STAFF REPORT: DECEMBER 14, 2022 MEETING

APPLICATION NUMBER: 22-8151

ADDRESS: 1451 BAGLEY

SCOPE: ERECT ADDITION, REPLACE WINDOWS, REPLACE STOREFRONT, ADD LIGHTING

Applicant site plan and rendering

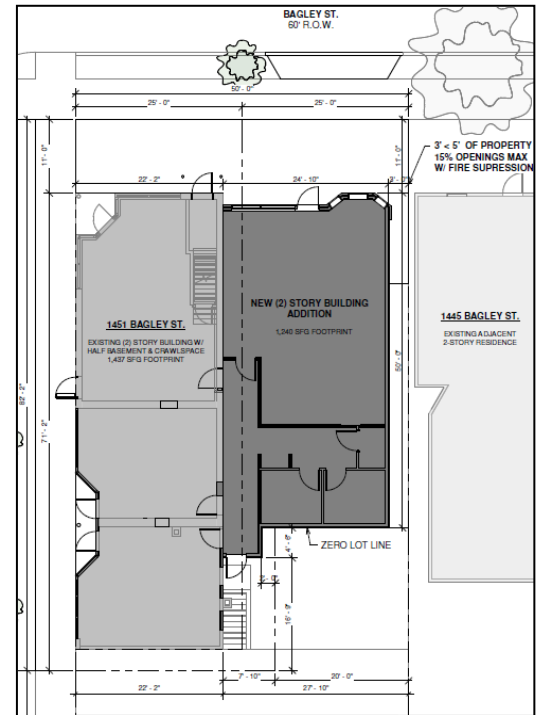
- It is not clear if historic wood siding remains under the T1-11 siding. Staff understands that with a building of this age, the original 19th century wood siding would have been milled from old growth lumber which is exceptionally dense and highly durable. Staff recommends the T-111 siding be removed, and if original siding and trim is present, then it should be retained, cleaned, and repaired. If there are areas where original cladding is missing, new wood siding can be cut to match the dimension, profile, and reveal of the original siding.

- If no siding is present, staff believes the installation of the composite siding will be appropriate at this location. The rear wall is minimally visible from the Trumbull sidewalk due to the proximity of the neighboring structure and sidewalk privacy fence. The east elevation wall of the original building will be entirely hidden from view at Bagley by the new construction.

- It is staff's opinion the expanse of glass within the fixed window openings at the front elevation's second story creates highly contemporary voids, and are contrary to the overall form and style of the proposed addition. ***Element 3, Proportion of openings within the facades*** states "*windows are almost always subdivided*". Staff believes the addition of a transom, necessitating a horizontal mullion, creates a straightforward subdivision of a window, as shown within the first floor openings, and is consistent with historic window openings in the district.

- Photo documentation of the existing exterior walls will be submitted to staff for review once the grooved plywood (T-111) siding is removed.
 - If original wood cladding is present, it will be retained. Paint color to be approved by HDC staff.
 - If no historic cladding is present, the composite siding specified for the new construction walls shall be approved.
- When the project is submitted for permit, the signage and mural will be removed from the drawing set.
